DATE: October 4, 2019
SOLICITATION NUMBER: FDLE ITN 710:0268
SOLICITATION TITLE: Florida Department of Law Enforcement Lease Space Needs
Escambia or Santa Rosa County
REPLY OPENING: November 19, 2019, 2:00 P.M. E.T.
ADDENDA NUMBER: Two (2)

Florida Department of Law Enforcement
ITN 710:0268 – Escambia and Santa Rosa County
Vendor Questions Posed Prior to and During the
Pre-Bid Meeting on September 18, 2019
Written Answers
October 4, 2019

100% CONSTRUCTION DOCUMENTS REVIEW

Culpepper Construction Company, Inc.
Pensacola Regional Operations Center, FDLE
100% Construction Document Submittal Review
January 18, 2018

1. C-101: Site Demolition Plan:

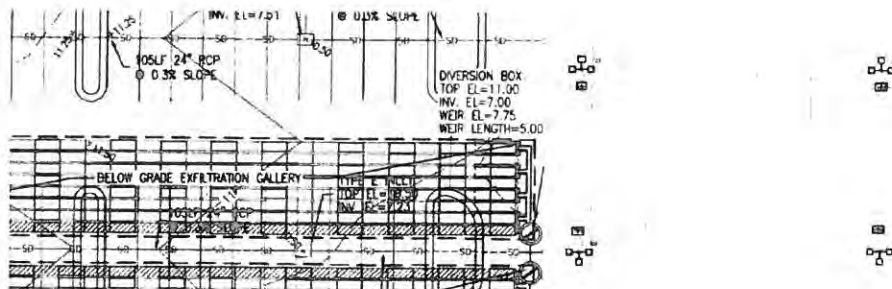
- Estimate Note: This drawing is indicating the complete removal of sidewalks around the perimeter of the site. (Earlier estimates assumed that the sidewalks would only be replaced as required to complete the new construction)
- Overhead Power at perimeter: In previous estimates, we anticipated that requirement for overhead power relocation and had included its cost in the earlier estimate revisions. On Drawing C-101 of the 100% CD submittal, drawing note indicates that this work is “by Others”. Based on this note the cost of this work has been deleted from the estimate. The coordination of this work remains with the scope of the work.
- Demolition of Curbs at Intendencia and De Villiers Street is not indicated and should be added to this plan.

- Coordinate C-103 and Plumbing P1.00A:

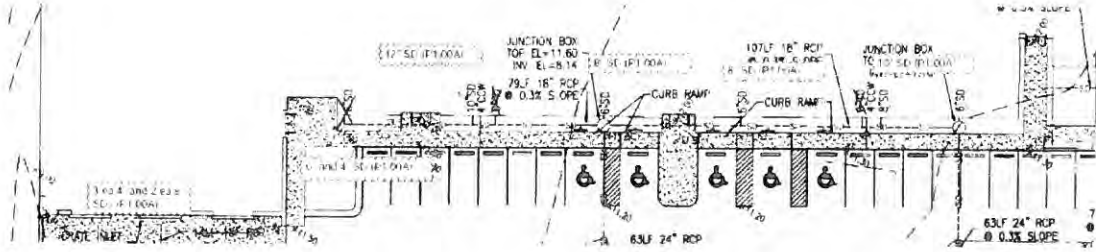
- Storm Drain from Warehouse is one 6" SD and three 4" , reference P1.00B. We recommend adding a manhole to enable the termination of these to the 12" RCP.
- Provide a structure schedule for the storm structures.

4. C-104 Utility Plan

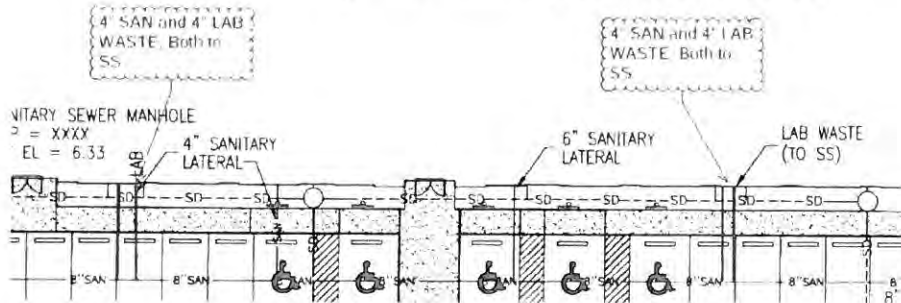
- Missing Top of Manhole elevation adjacent to building
- Lab waste and adjacent sanitary waste not clearly defined on this sheet.

A1.01B

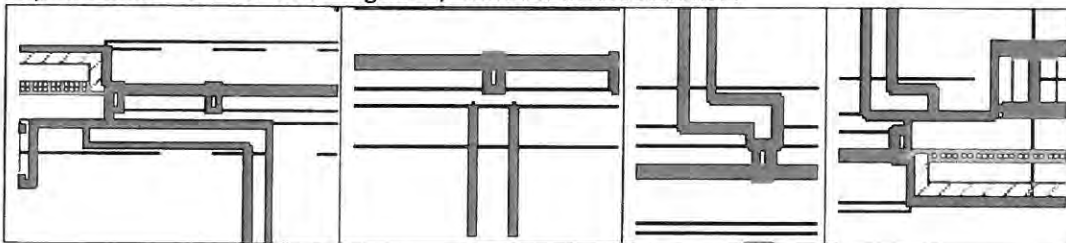
- No details are provided for the operable walls at the training rooms.

A4.01

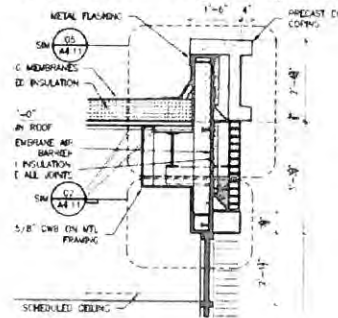
- Section 04/A4.01 | Floor 2 window head at entrance: Details indicates that wind load of the window at the head is picked up by the suspended precast. Consider providing direct framing for window head to building structure.
- Coping detail will be multiple pieces of precast consisting of horizontal coping and vertical panel.
- Window blinds and/or blind pockets are not indicated in the drawings or specifications. The estimate includes a budget for blinds at storefront windows.
- Wall sections don't reference the air barrier specified in 072713. [would like to propose changing to a fluid applied air-barrier in lieu of the rolled product specified].
- Overflow Scuppers Location: Please review/Confirm the overflow scupper location.

- Detail Below: Why are we framing and wrapping this beam? Ceiling intersects window @ mullion.
- Detail Below: Is glass spandrel over horizontal mullion?

A4.04

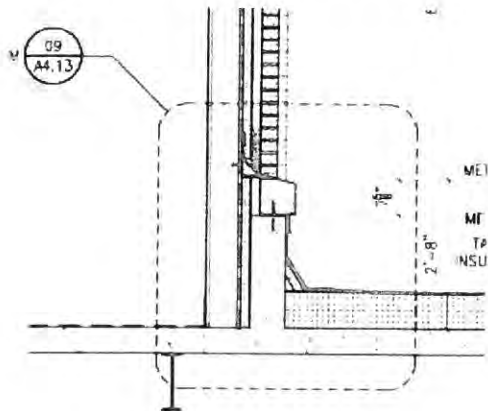
- Confirm that the concrete curbs (09/A4.13) show up on the structural plans.

M1.01A

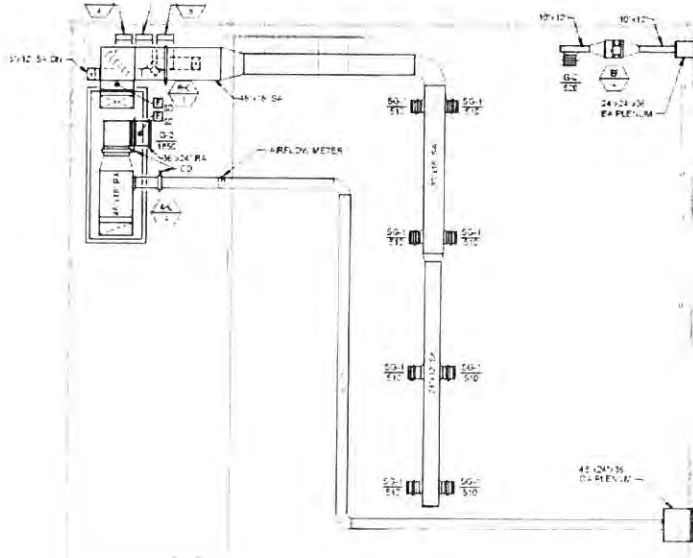
- Route 50x16 SA south to avoid conflict with Ballistic wall @ 1813.
